HISTORIC AND DESIGN REVIEW COMMISSION

May 01, 2019

HDRC CASE NO: 2019-226
ADDRESS: 933 BURNET ST
LEGAL DESCRIPTION: NCB 1656 BLK D LOT S 131 FT OF 18
ZONING: RM-6, H
CITY COUNCIL DIST.: 2
DISTRICT: Dignowity Hill Historic District
APPLICANT: Travis Louie
OWNER: Yet Homes LLC
TYPE OF WORK: Exterior modifications, fenestration modifications, installation of porch railings
APPLICATION RECEIVED: April 11, 2019
60-DAY REVIEW: June 12, 2019
CASE MANAGER: Edward Hall
REQUEST:

Existing elevations

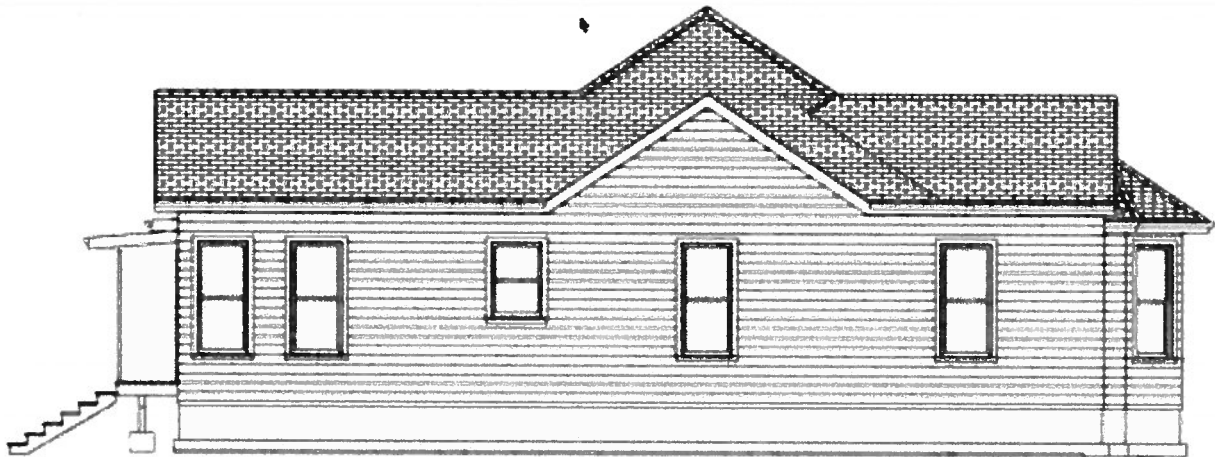
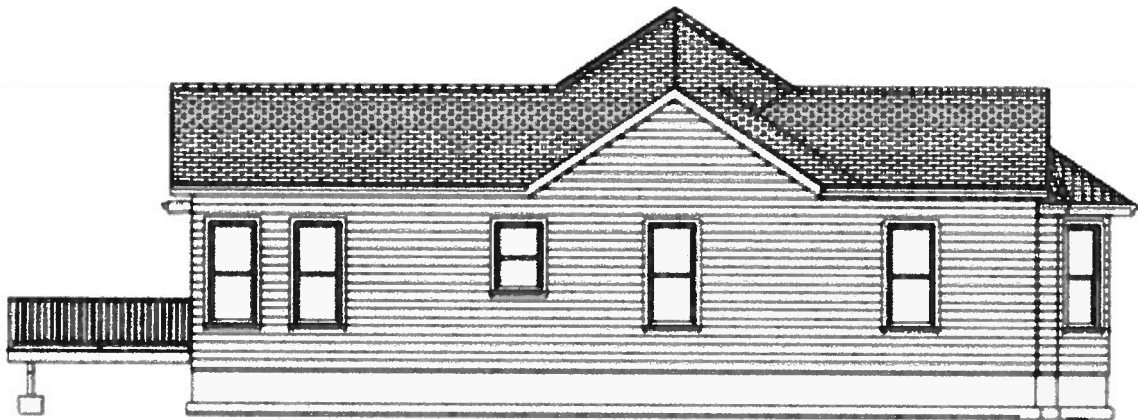
- f. EXTERIOR MODIFICATIONS (North façade) – The applicant has proposed to modify the fenestration pattern on the north (rear) façade by modifying an existing window opening to become a door opening and modifying an existing door opening to become a window opening. Per the 1912 Sanborn Map, the existing window opening is located on an addition that is not original to the structure. Additionally, the window opening feature a head height that is not consistent with those found elsewhere on the historic structure. Given that the proposed modifications will occur on a non-primary façade, staff finds them to be appropriate; however, the proposed new window opening should feature a salvaged wood window and be installed in a manner than matches those found historically on the structure.

- g. EXTERIOR MODIFICATIONS (East façade) – The applicant has proposed to modify the fenestration pattern on the east (Willow) façade by eliminating one window opening under the gable and centering the remaining window opening. The Guidelines for Exterior Maintenance and Alterations 6.A.i. notes to preserve existing window and door openings. Provided that these openings are on a primary, street facing façade, staff finds the proposed modifications to be inappropriate and inconsistent with the Guidelines.

- i. That all repair scopes be done in-kind with like materials.
- ii. That the replacement porch columns be six (6) inches square and feature both capital and base trim, that a profile for porch skirting be submitted to staff for review and approval and that the proposed porch decking be installed perpendicular to the front porch wall and feature a 1x3 inch profile.
- iii. That the proposed porch railings be simple in design, feature both a top and bottom rail with the bottom rail featuring a vertical orientation and be installed approximately three to four inches above the porch decking.
- iv. That the modified opening feature a salvaged wood window and be installed in a manner that matches the window installations found historically on the house.

Staff does not recommend approval of item #5, exterior modifications on the east (Willow) facade based on finding g.
